**AGENDA**  
**PLANNING AND ZONING COMMISSION MEETING**  
**CITY OF CREVE COEUR, MISSOURI**  
**TUESDAY, JANUARY 19, 2016**  
**7:00 PM**

1. **Application #16-001: APPROVAL OF NEW PARKING LOT IMPROVEMENTS AND LIGHTING FIXTURES OF THE AMERICAN OPTOMETRIC ASSOCIATION BUILDING AT 243 N. LINDBERGH BOULEVARD**

**APPLICATION TO PLANNING AND ZONING COMMISSION**  
**#16-001 APPROVAL OF NEW PARKING LOT IMPROVEMENTS AND**  
**LIGHTING FIXTURES OF THE AMERICAN OPTOMETRIC**  
**ASSOCIATION BUILDING AT 243 N. LINDBERGH BOULEVARD**  
**FOR THE MEETING OF: Tuesday, January 19, 2016**

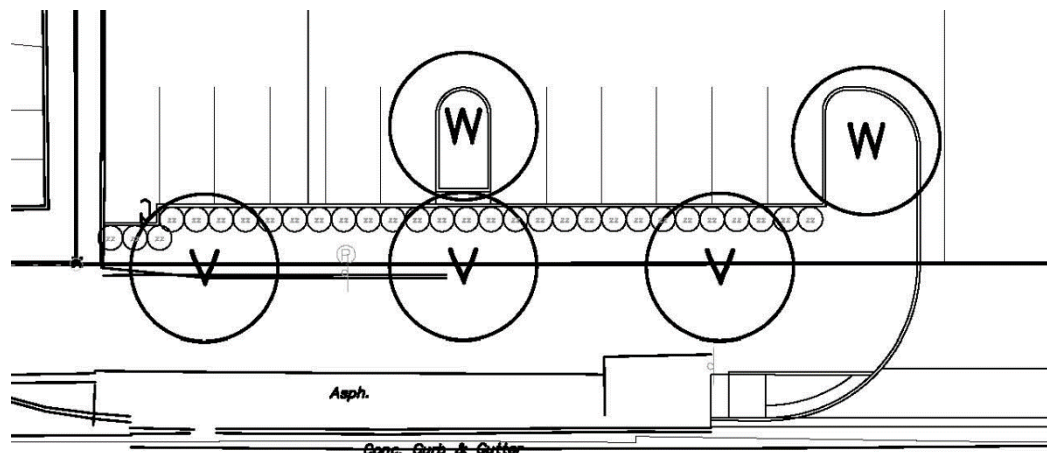
The application includes new lighting to the front of the building that will have up-lighting to highlight the new building façade, per the image below:

SITE PHOTOMETRICS

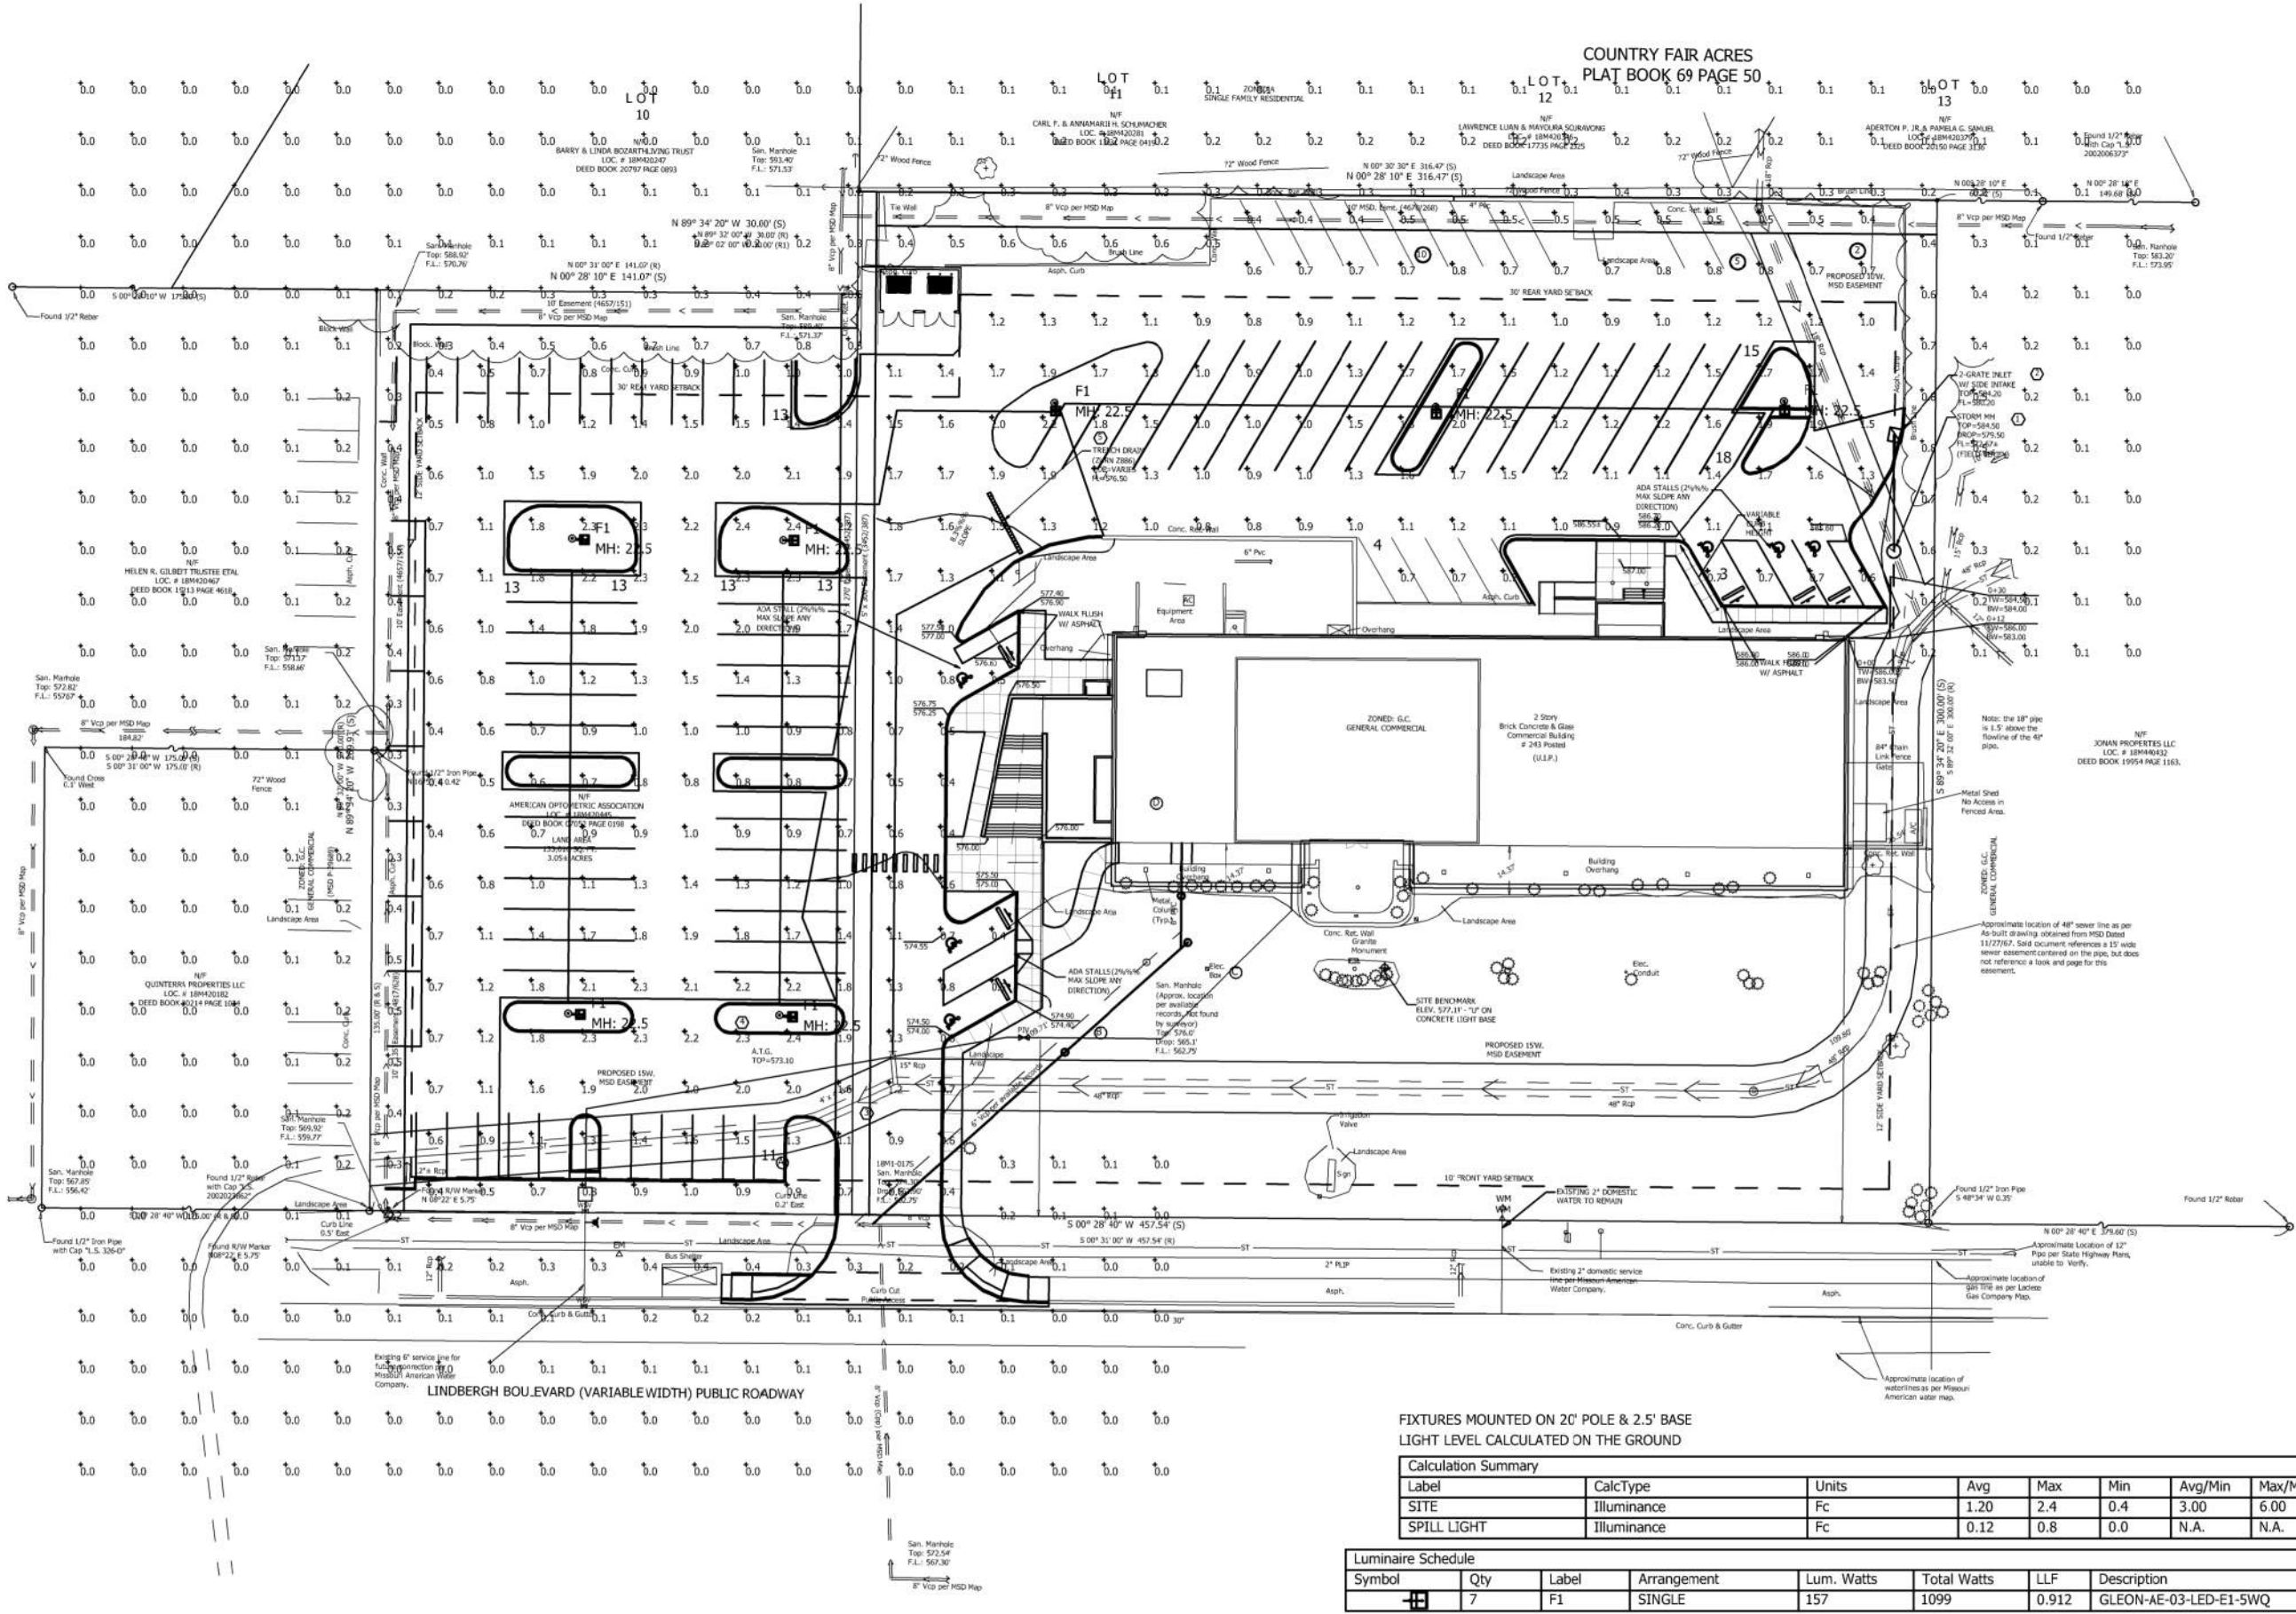
The proposal includes seven new LED light fixtures through-out the parking lot, and new wall mounted fixtures. The parking lot fixtures will be mounted on a 20 foot tall pole with a 2.5 foot base that meets with the Zoning Regulations. The photometric plan indicates a maximum illumination of 1.0 at the property line along Lindbergh Boulevard, 0.5 near the southeast property line, and 0.2 to 0.4 at the west property line abutting residential properties. The new landscaping provided thought the parking lot should also have a dampening effect on the lighting at the property lines.

Figure 4: Close-up of the Landscape Plan at the existing entrance.

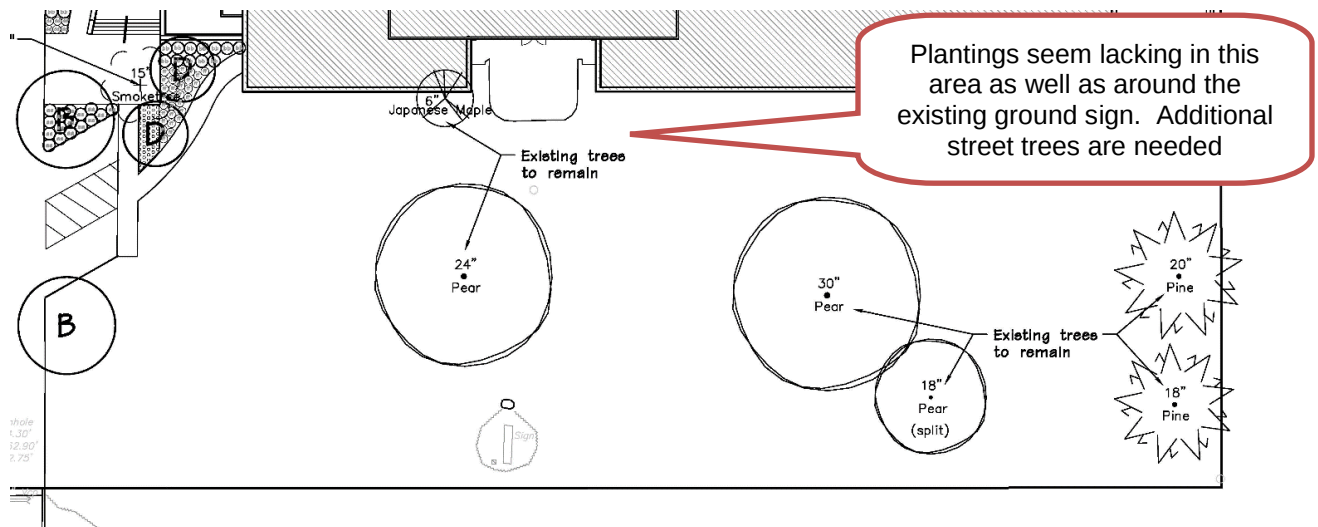
6. New landscaping is provided along with new walkways, stairs, and the new accessible parking spaces, as well as including additional planting for the employee entrance on the west elevation. The front of the building has an open park-like lawn appearance, which is well maintained and in keeping with the Design Guidelines. However, as discussed further below, additional plantings are needed to meet with the street tree requirements and the plantings at the existing entrance that

will now become an employee area seems lacking. Therefore, Staff has included a recommendation of approval that the Landscape Plan should be revised to meet with the Design Guidelines and Zoning Code Requirements by adding three shade trees in the front setback and a mix of material near the new patio.

- The Landscape Plan shall be revised to provide for the appropriate number of street trees, and plantings to meet with Section 405.540 Landscaping and with Design Guidelines for the Zoning Administrator's approval, and as discussed in the Staff Report on Application #15-013.

Figure 5: Close-up of existing site with the sidewalk along Lindbergh Blvd and the proposed site plan indicating new sidewalk at the entrance

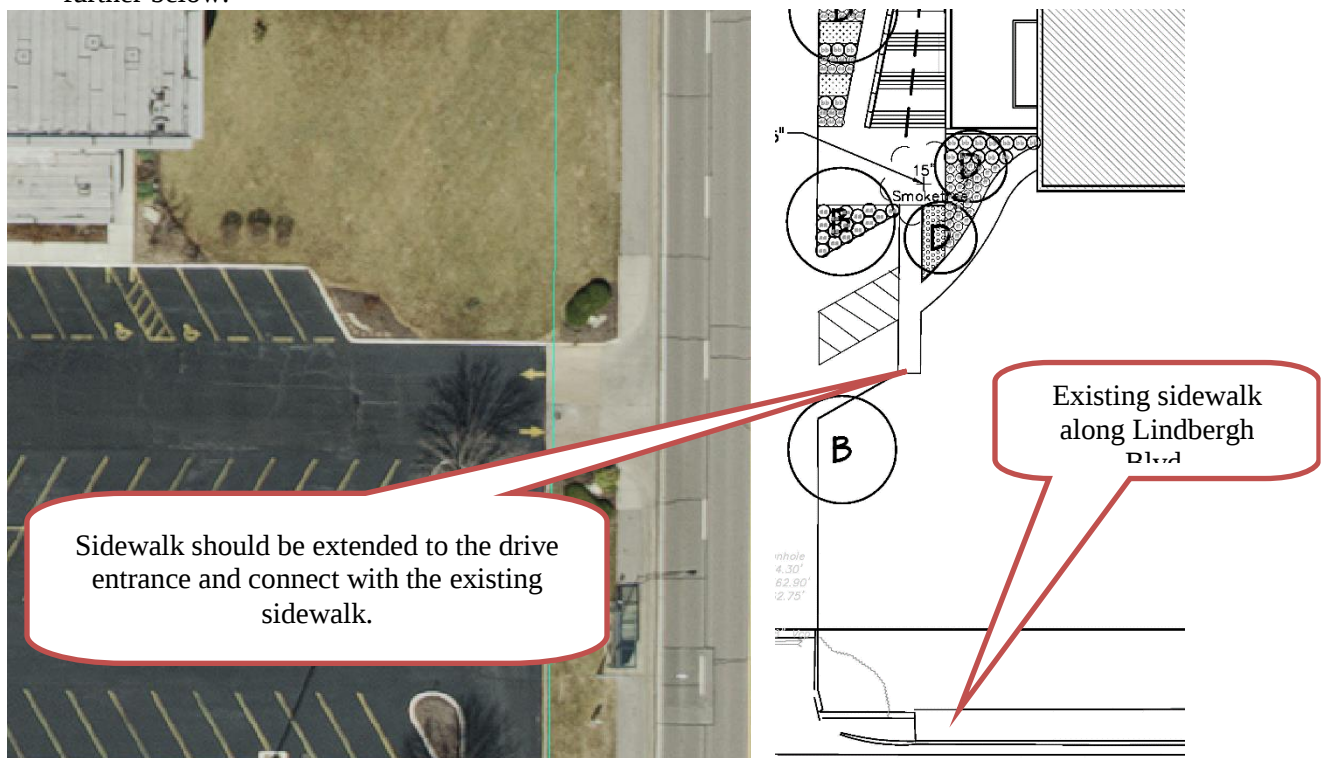
7. The Design Guidelines discusses providing pedestrian linkages wherever possible, as well as providing for such between the street and the main entrance of the building. There is an existing sidewalk that is adjacent to Lindbergh Boulevard, and new sidewalks are provided to the new entrance. However, they are not shown to extend beyond the accessible parking spaces. Therefore Staff has included a condition of approval that the sidewalk is to be extended to the existing sidewalk along Lindbergh Boulevard at the drive-entrance in furtherance of the Design Guidelines and to meet with the minimum requirements of Section 405.730 Sidewalks discussed further below.

Section 405.730 Sidewalks requires that all non-residential developments requiring site concept plan and /or site development plan approval must provide safe, clearly defined and direct access between buildings and from the principal building's entrance to the public sidewalk. The minimum width of all internal sidewalks in non-residential development shall be at least six feet or eight feet if used as a curb stop. The Concept Landscape Plan is indicating a sidewalk width of five feet. Therefore, Staff has included a recommendation that all sidewalks meet with the minimum width requirements and that the sidewalk from the newly accessible parking spaces and entrance shall be extended to meet with the existing sidewalk along Lindbergh Boulevard.

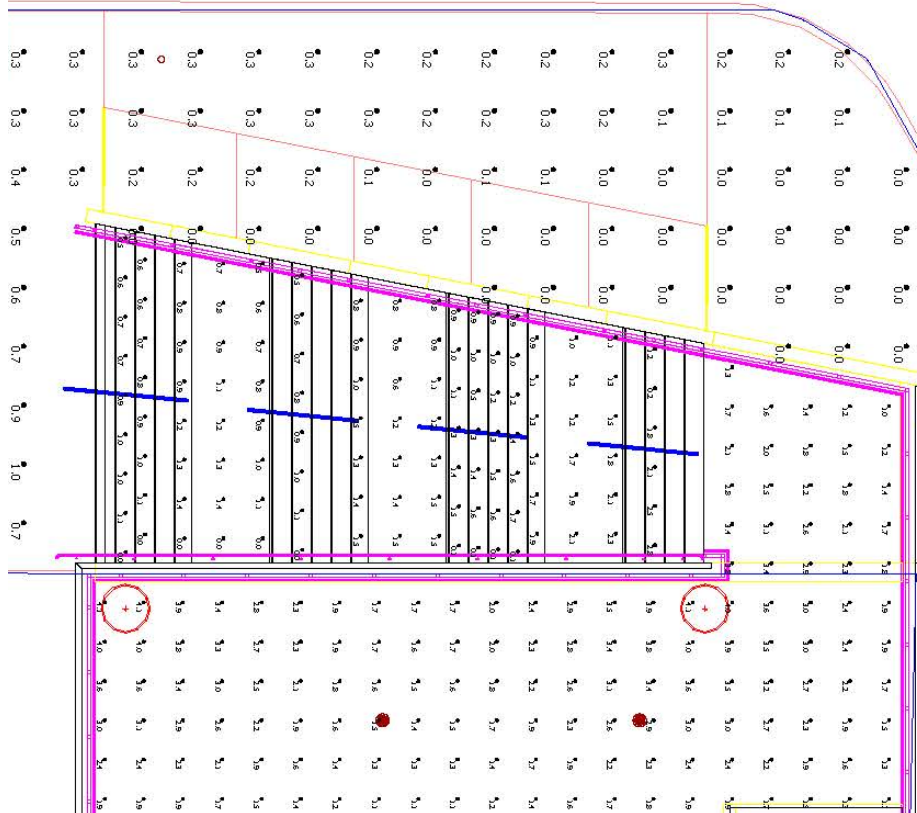
The proposed light element will have a greater cutoff greater than the allowed. While the lighting is directed downward, by the use of the aluminum shield, the light measurements submitted has a Candlepower Distribution table showing: 197.8 candela at 75 degrees, 23.2 candela at 90 degrees, and 1.5 at 180 degrees. The photometric plan indicates an illumination of 0.3 at the new downstairs walkway, and does not cast upon adjacent property, per the image below:

The new deck is approximately 144 feet from the residential property to the west. And approximately 108 feet from the east property line along Lindbergh Boulevard.

Whether the columns provide exceptional architectural elements or detail is ultimately up to the Commission members to determine. It does provide for a new unique lighting for the new plaza deck, and the lighting cast is less than one candle over the lower walkway area. If the Commission wishes to have these fixtures turned off at 10:00 pm, a motion for such will need to be included.

Figure 8: Proposed Site Plan

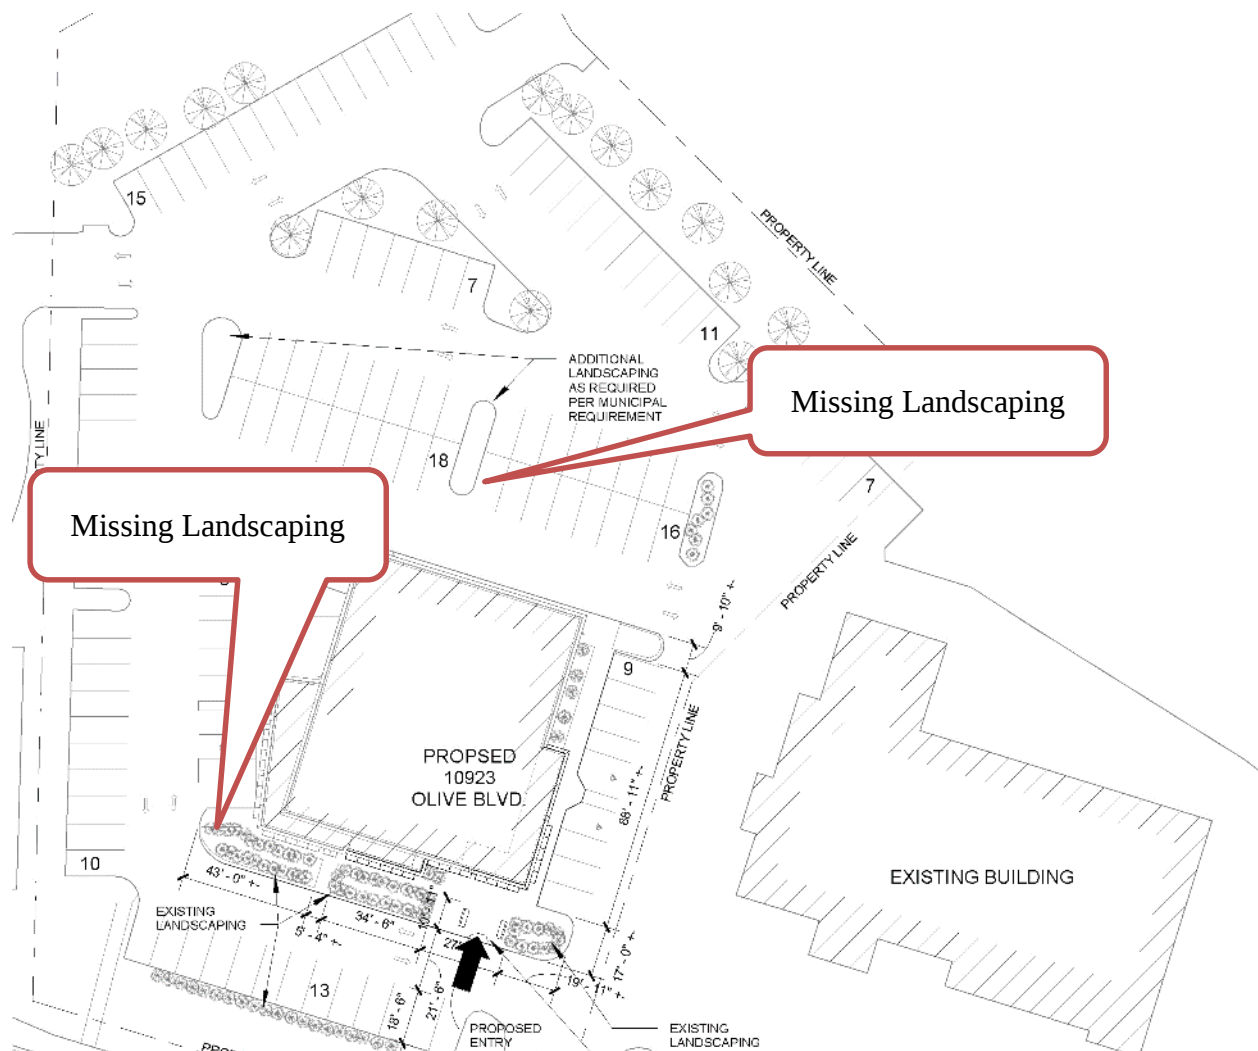
The Applicant is not proposing any significant changes to the site. However, the site plan is showing the loss of landscaping over time in the islands and in front of the building. The landscaping along Olive Boulevard was replaced this fall to be consistent with the prior approved Landscape Plan. However, the landscaping in the parking lot and adjacent to the building was not addressed at that time. Therefore, a condition of approval includes that a landscape plan shall be submitted showing the replacement the landscaping within these areas as well as incorporating the plantings along Olive Boulevard for the Zoning Administrator's approval, so that all landscaping for the Shops of Westchase center is provided on one landscape plan.
